ADDRESS: 25 S VAN PELT ST

Proposal: Alter facades; construct fourth-floor addition

Review Requested: Final Approval

WEST ELEVATION
(PROPOSED)

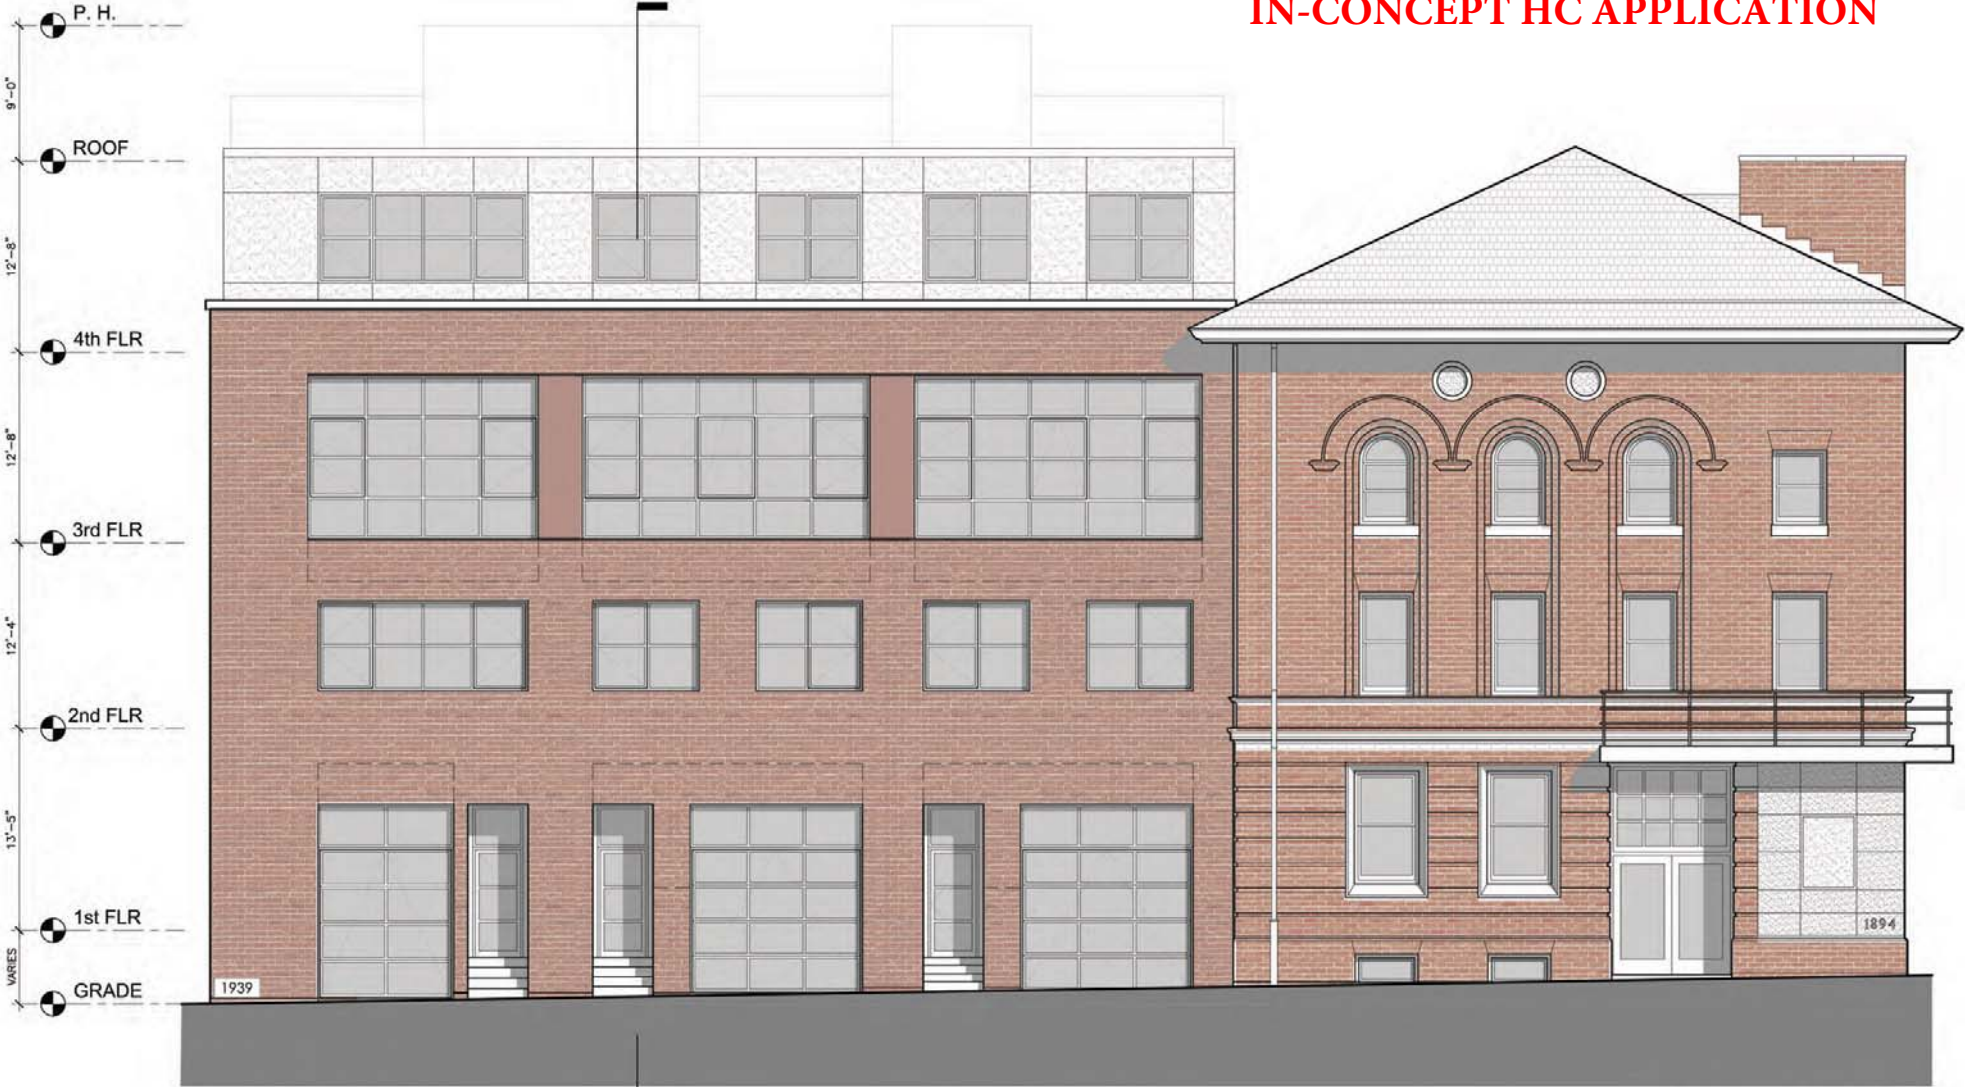
- This application proposes to alter the number, location, and size of windows on the primary elevation of the building, to cut new window openings on the primary façade.

- The staff suggests that it may be possible to cut minimal new openings to provide code-required egress, but does not recommend approval of the installation of garage entrances on the primary elevation.

- The application does not comply with this guideline.
- *Roofs Guideline | Recommended: Designing rooftop additions, elevator or stair towers, decks or terraces, dormers, or skylights when required by a new or continuing use so that they are inconspicuous and minimally visible on the site and from the public right-of-way and do not damage or obscure character-defining historic features.*

- The proposed rooftop addition would be visible from the public right-of-way.
 - The application does not comply with this standard.

STAFF RECOMMENDATION: Denial, pursuant to Standard 2 and the Windows and Roofs Guidelines.

EAST ELEVATION
(PROPOSED)

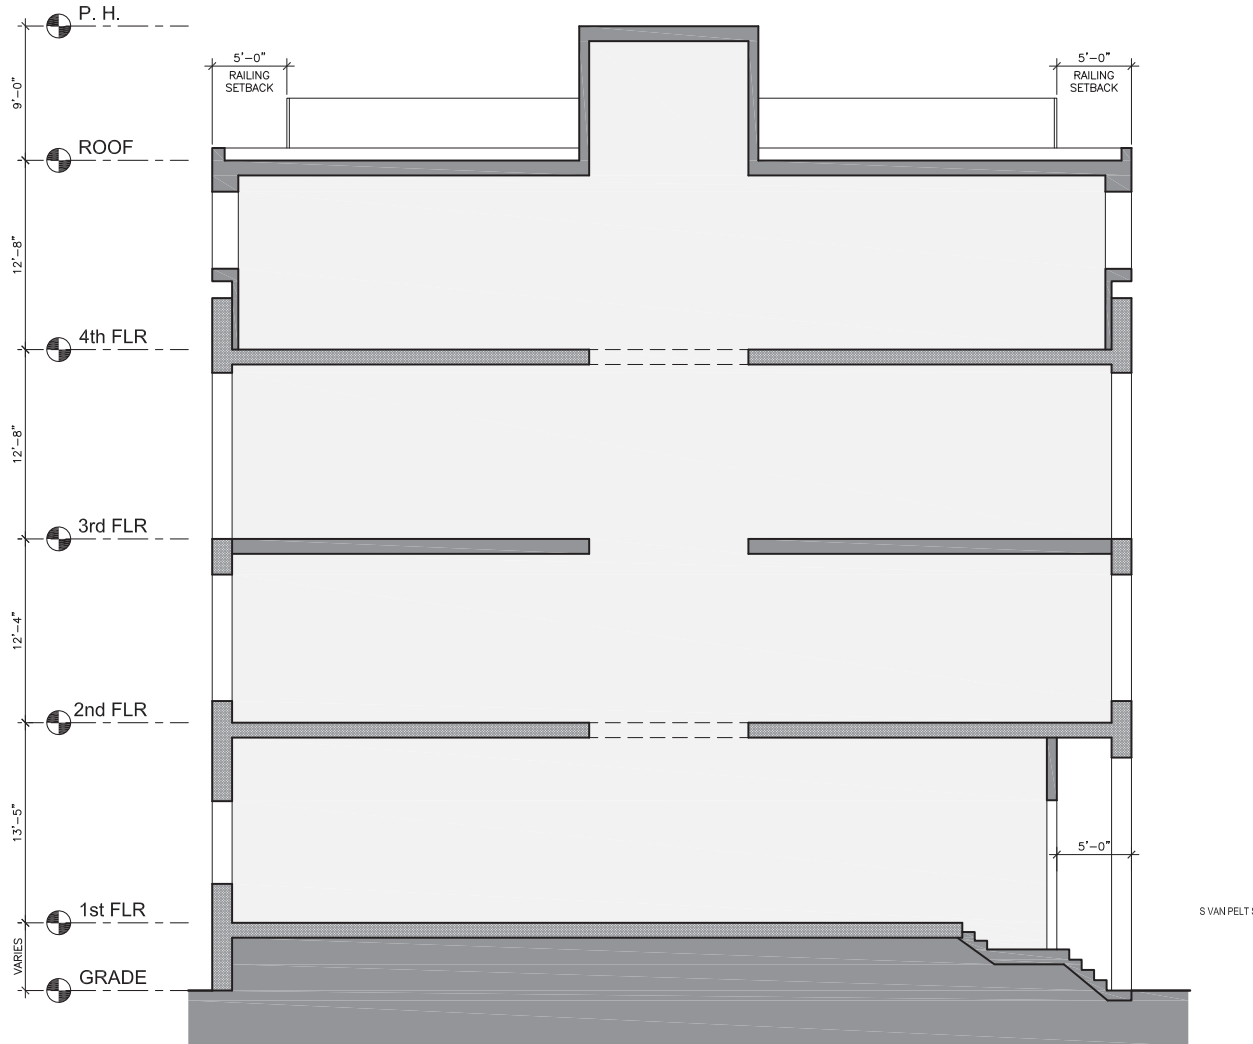
Second, Third, & Fourth Floors: Similar to the proposed modifications at the West façade.
